UNITED STATES  
NUCLEAR REGULATORY COMMISSION  
WASHINGTON, D.C. 20555-0001

SUBJECT: QUAD CITIES NUCLEAR POWER STATION, UNITS 1 AND 2 - STAFF ASSESSMENT OF INFORMATION PROVIDED PURSUANT TO TITLE 10 OF THE *CODE OF FEDERAL REGULATIONS* PART 50, SECTION 50.54(f), SEISMIC HAZARD REEVALUATIONS FOR RECOMMENDATION 2.1 OF THE NEAR-TERM TASK FORCE REVIEW OF INSIGHTS FROM THE FUKUSHIMA DAI-ICHI ACCIDENT (TAC NOS. MF3879 AND MF3880)

STAFF ASSESSMENT BY THE OFFICE OF NUCLEAR REACTOR REGULATION  
RELATED TO SEISMIC HAZARD AND SCREENING REPORT  
QUAD CITIES NUCLEAR POWER STATION, UNITS 1 AND 2  
DOCKET NOS. 50-254 AND 265

Figure 3.3-1 Plot of Staff's and Licensee's Base Case Shear-Wave Velocity Profiles for the Quad Cities Site

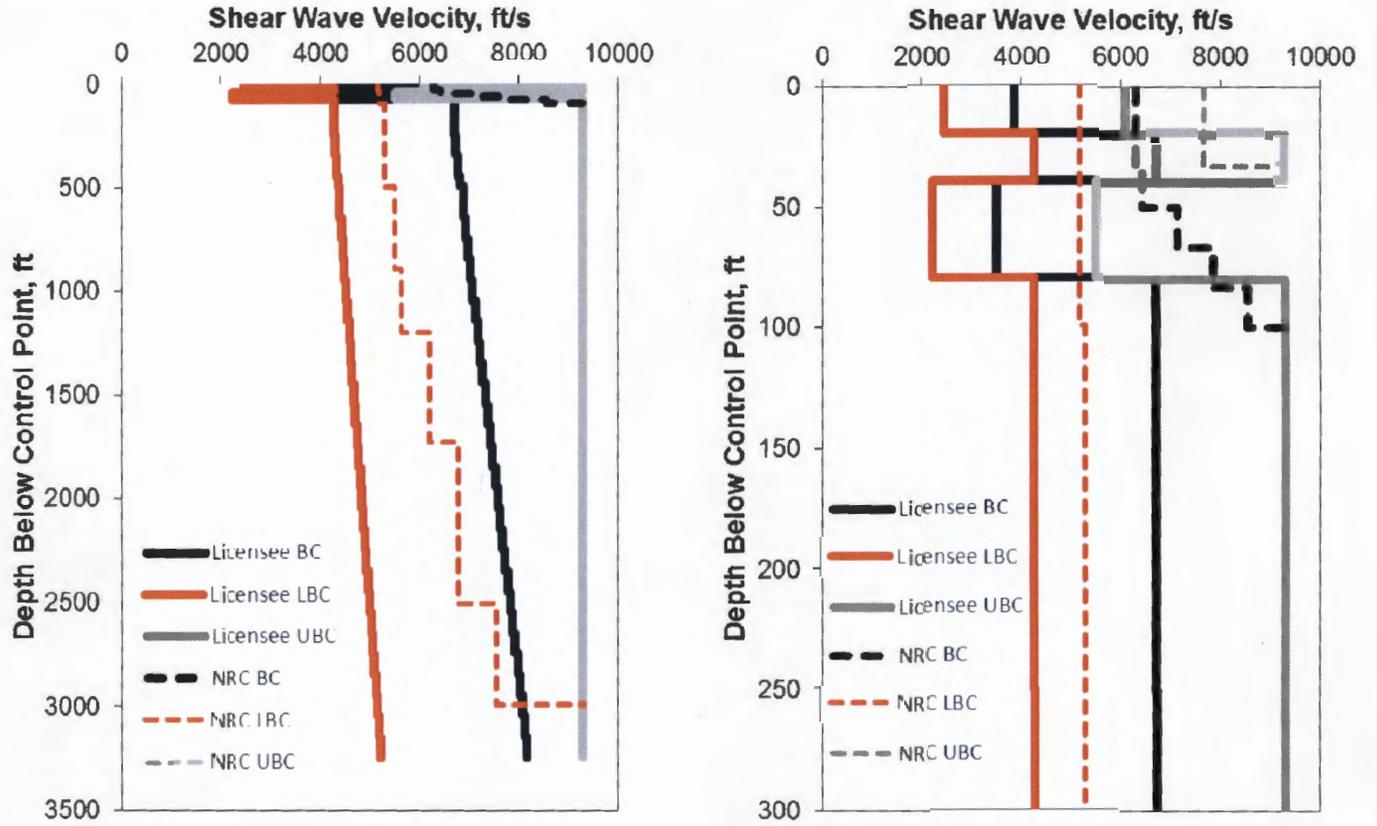
To perform its confirmatory analysis, the NRC staff utilized information from the Quad Cities Plant Design Analysis Report (PDAR) to estimate the near surface shear wave velocity of the dolomite from the Sulirian Niagaran Formation. Because the estimated near surface shear wave velocity is in the lower range for typical dolomites, NRC staff applied judgement in estimating the lower base case shear wave velocity. The upper base case velocity was estimated using a scale factor of 1.2, corresponding to a natural log standard deviation of 0.15. The NRC staff used the template velocity profiles from the SPID to estimate the shear wave velocities for the deeper layers. Figure 3.3-1 shows a comparison of the licensee's and staff's three base case velocity profiles. As shown in Figure 3.3-1, the staff's profiles are generally higher than the licensee's and do not include the licensee's low velocity zone between 50 and 75 ft (15 and 23 m). The reason for the difference is that the NRC staff relied primarily on the representative dolomitic bedrock properties in Table II-5-2 of the PDAR to characterize the near surface shear wave velocity. As such, the staff's three velocity profiles are generally higher than those estimated by the licensee. In contrast, the licensee appears to have assigned lower velocities to the soft solution-riddled zones between 50 and 75 ft (15 and 23 m). However, these dolomites beneath the plant were grouted prior to construction of the plant and likely now have somewhat higher shear wave velocities.

Figure 3.3- 1 Plot Comparing the Staff's and the Licensee's Median Amplification Functions and Uncertainties for the Quad Cities site.

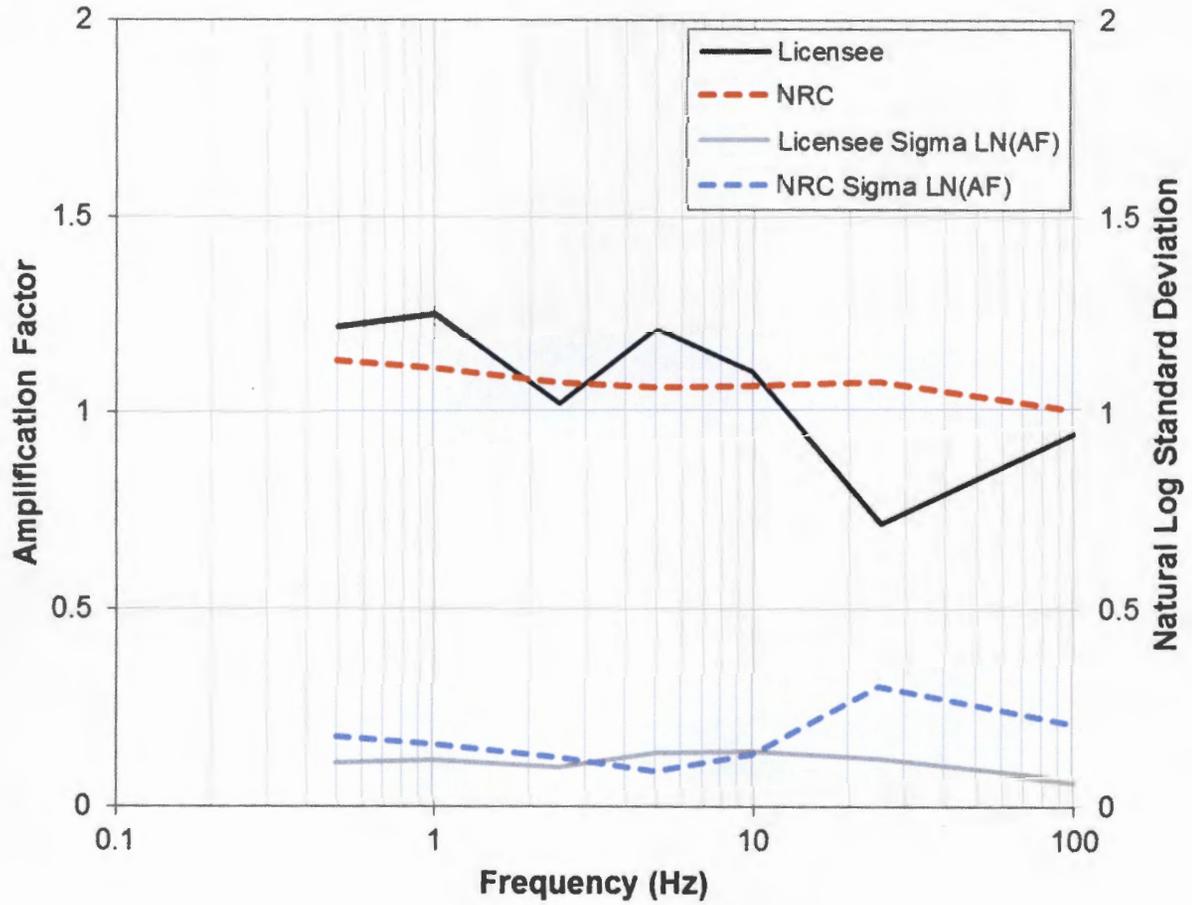
Figure 3.3-2 of this assessment shows a comparison of the staff's and licensee's median site amplification functions and uncertainties for the input loading level of 0.05 g. The licensee's and staff's amplification functions are similar with moderate differences in amplification at 25 Hz.

This difference is due to the differences between the staff's and licensee's near surface shear wave velocity profiles in the upper 50 to 75 ft (15 to 23 m). As shown in Figure 3.3-3, these differences do not substantially impact the lower frequency control point hazard curves, which are very similar. However, the staff's PGA control point hazard curve is moderately higher than the licensee's curve due to the differences in the best estimate base case and upper base case velocity profiles.

Figure 3.4-1 Comparison of the Staff's GMRS with Licensee's GMRS and the SSE for the Quad Cities site

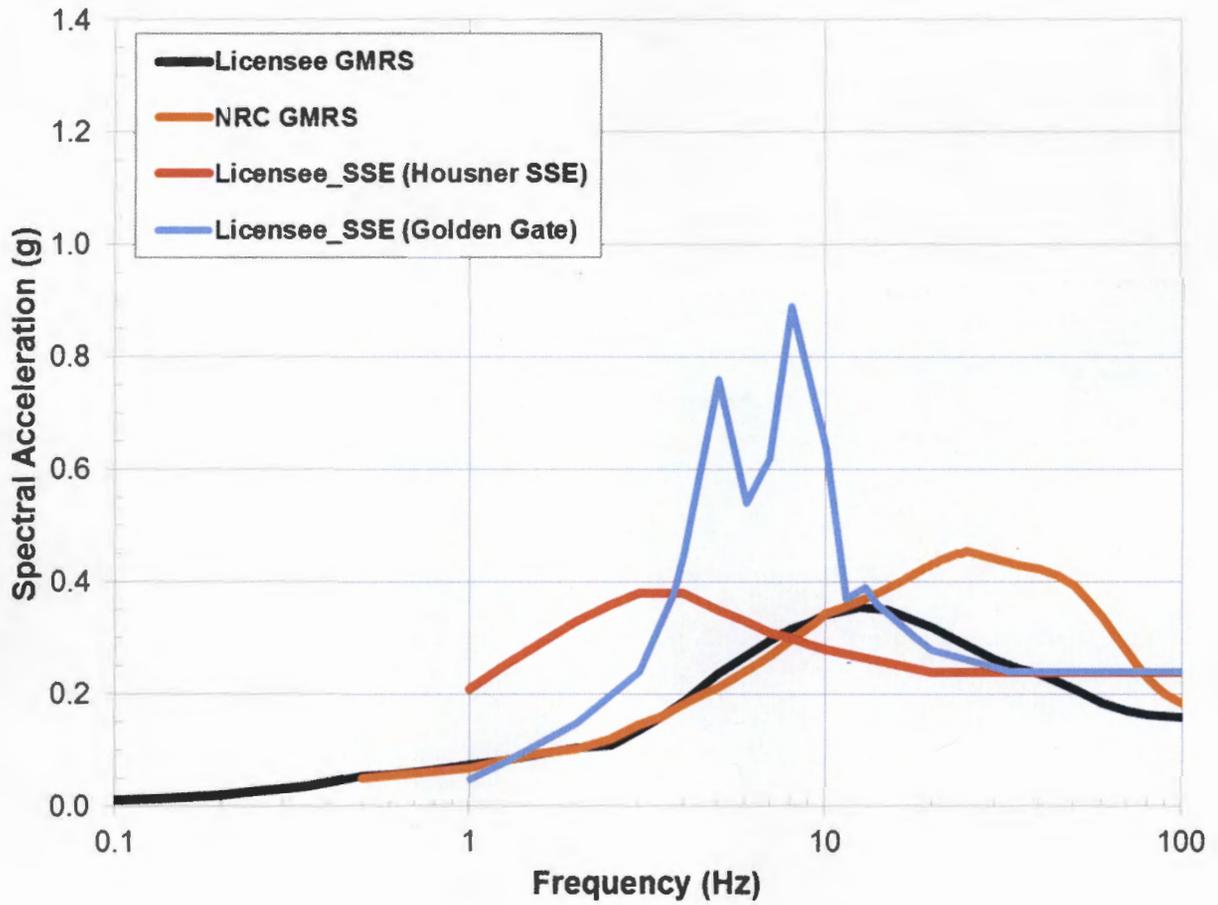
The NRC staff independently calculated the  $10^{-4}$  and  $10^{-5}$  UHRS using the results of its confirmatory PSHA and site response analysis, as described in Sections 3.2 and 3.3 of this staff assessment, respectively. Figure 3.4-1 of this assessment shows a comparison of the GMRS determined by the licensee to that determined by the NRC staff.

As shown in Figure 3.4-1 below, the licensee's GMRS shape is generally similar to that calculated by the NRC staff up to 10 Hz. At frequencies above 10 Hz, the GMRS determined by the licensee is lower from that determined by the NRC staff. As described above, these differences in GMRS are the result of differences in the site response analyses performed by the licensee and NRC staff as discussed in Section 3.3 above. The NRC staff concludes that these differences are acceptable for this application because the licensee followed the guidance provided in the SPID with respect to both the PSHA and site response analysis for the Quad Cities site.

The NRC staff confirms that the licensee used the present-day guidance and methodology outlined in RG 1.208 and the SPID to calculate the horizontal GMRS, as requested in the 50.54(f) letter. The NRC staff performed both a PSHA and site response confirmatory analysis and achieved results consistent with the licensee's horizontal GMRS. As such, the NRC staff

concludes that the GMRS determined by the licensee adequately characterizes the reevaluated hazard for the Quad Cities site. Therefore, this GMRS is suitable for use in subsequent evaluations and confirmations, as needed, for the licensee's response to the 50.54(f) letter.
